National World War I Memorial

Pershing Park
14th Street and Pennsylvania Avenue, NW
Washington, DC

Revised Concept Review

Commission meeting date: July 13, 2017

October 2016 Concept Design

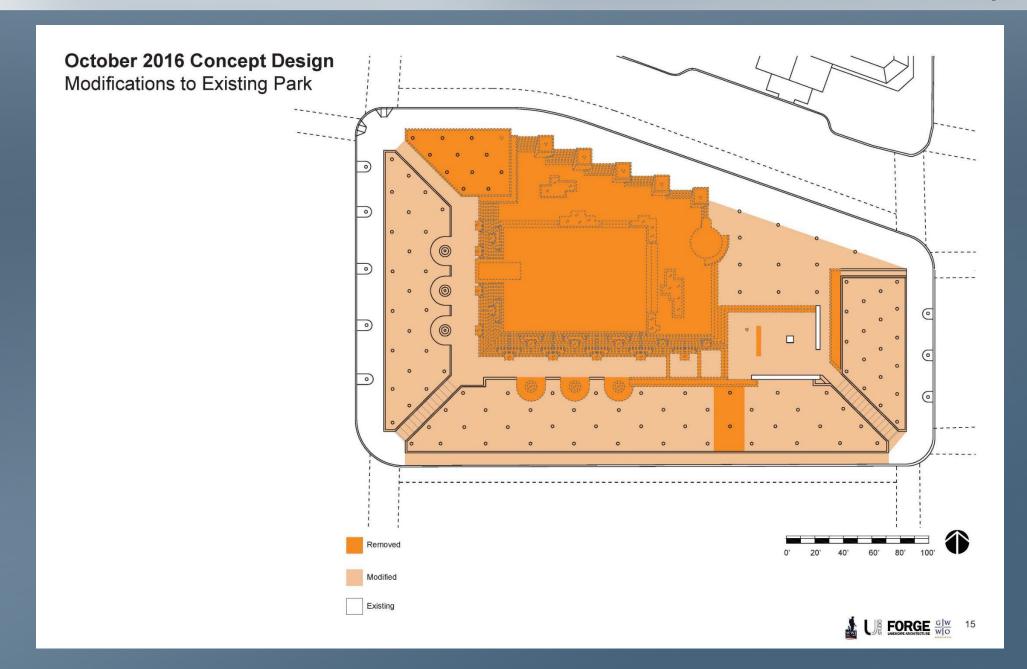
NCPC Executive Director's Recommendation comments received November 3, 2016 in response to October Concept Design:

- Provide National Environmental Policy Act (NEPA) alternative with a rehabilitation approach with minimal changes to existing park features
- Denote existing park elements to be retained, reused, or rehabilitated for the memorial
- Provide plan and renderings that denote the limits of the PADC streetscape and how the street-scape transitions into memorial space
- Further develop northern portion of the site to better define the sidewalk zone, increase green space, and create a clear transition between the public street and the memorial area
- Further explore possibilities to reuse or rehabilitate more of the existing features, including steps, planters, and waterfall.

- Shifts the bas-relief wall west into a sunken central room within the park
- Improves universal accessibility throughout the park
- Increases visual access into and out of the park
- Creates stronger connections with the urban context
- Proposes enduring and maintainable features and materials
